**RE: 3919 Watson PL NW (Square 1806, Lot 0025) REVISED
26-Z-PDRM-00051**

Applicable Zoning Criteria Analysis

SQ. 1806 Lot 25 3919 Watson Pl NW
Site Plan

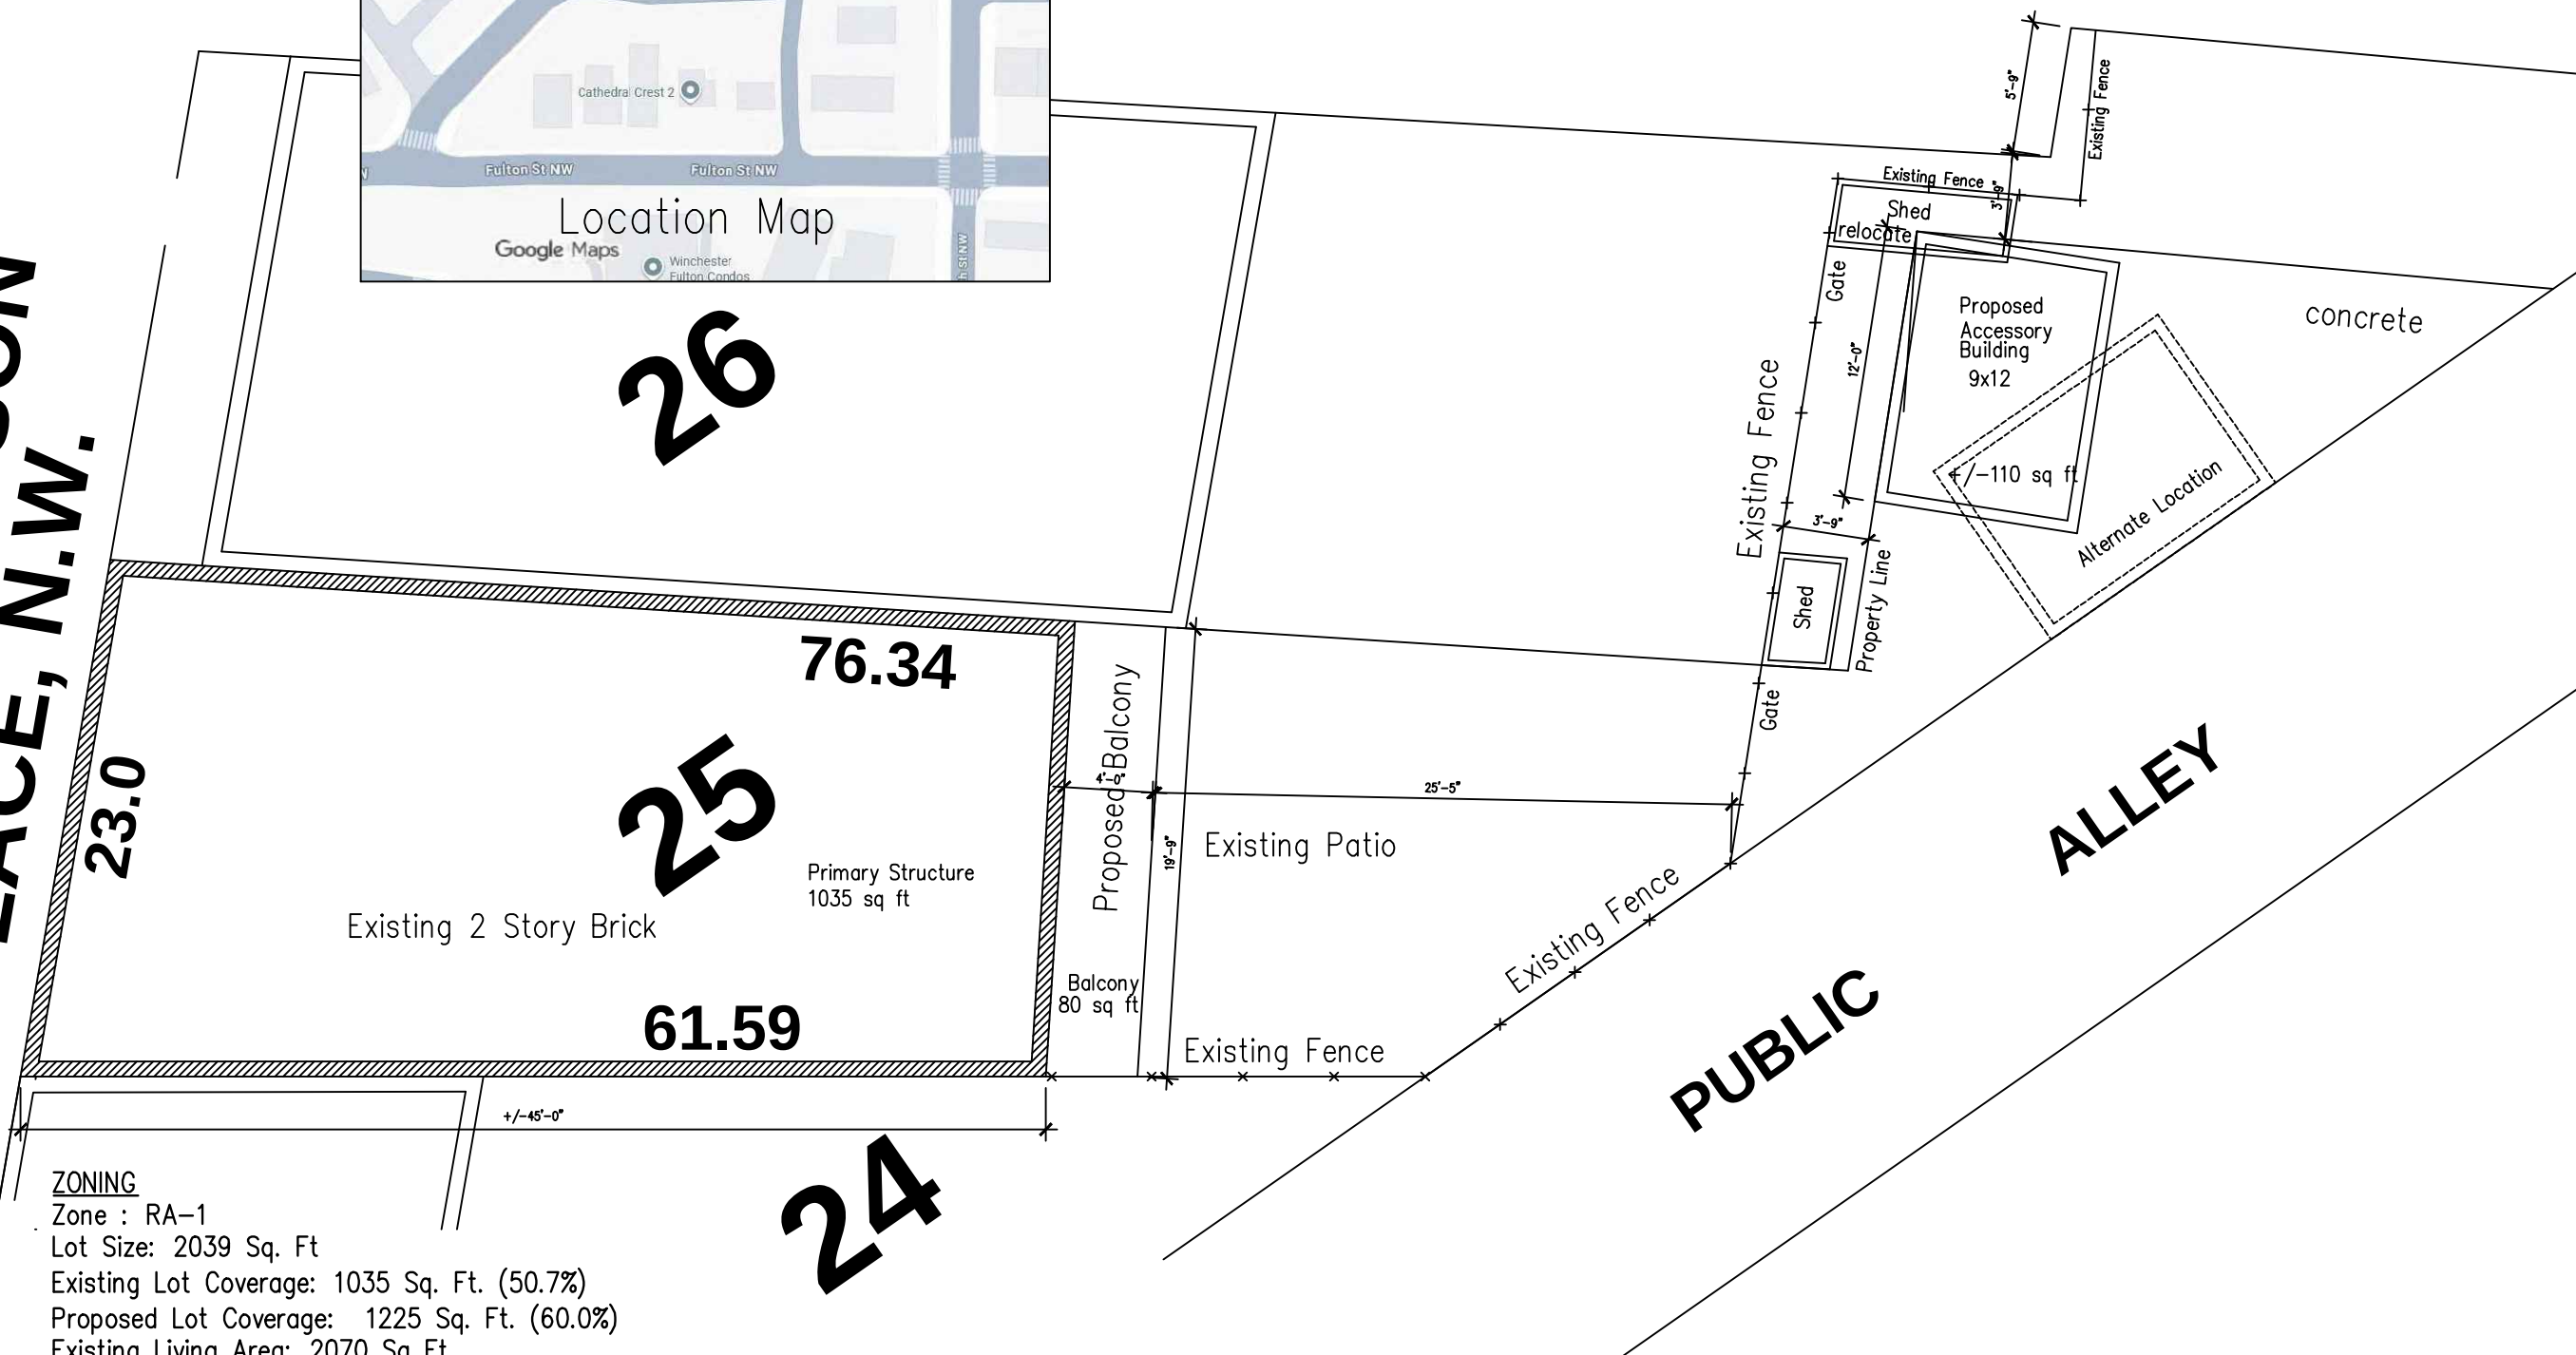
Criteria	Zoning Reference	Allow./Req.	Existing	Proposed
FAR	F § 201.1	0.9	Not provided	Not provided
Rear Yard	F § 207.1	20 ft.	53 ft.	49.5 ft.
Side Yard	F § 208.2	No side yard required for row buildings	N/A	N/A
Lot Occupancy	F § 210.1	40% max.	50.7%	60% Special Exception Required
Accessory Building Rear Yard	F § 5003.1	7.5 ft. setback from alley centerline	N/A	10.5 ft.
		May not occupy more than 30% of the required rear yard	N/A	Would not occupy greater than 30% of the required rear yard

Pursuant to B-318.7, where a lot does not have a rear lot line, such as when the side yards converge at a point, or where the rear lot lines intersect at an angle less than ninety degrees (90°), a required rear yard shall be measured as an arc from the point opposite the front lot line(s). Measuring the rear yard as an arc from the point opposite the front lot line results in a conforming rear yard. Furthermore, the proposed accessory building would not occupy greater than 30% of the required rear yard.

Pursuant to F-5000.3, accessory buildings shall be included in the calculation of lot occupancy and the floor area ratio (FAR) of the RA zones. The proposed accessory building and proposed balcony, greater than 4 feet in height above grade, would count towards lot occupancy. The property is nonconforming for lot occupancy and the proposed project would increase the existing nonconforming condition and would require special exception relief pursuant to F-5201.1(a) for the proposed balcony and F-5201.2(a) for the proposed accessory building.
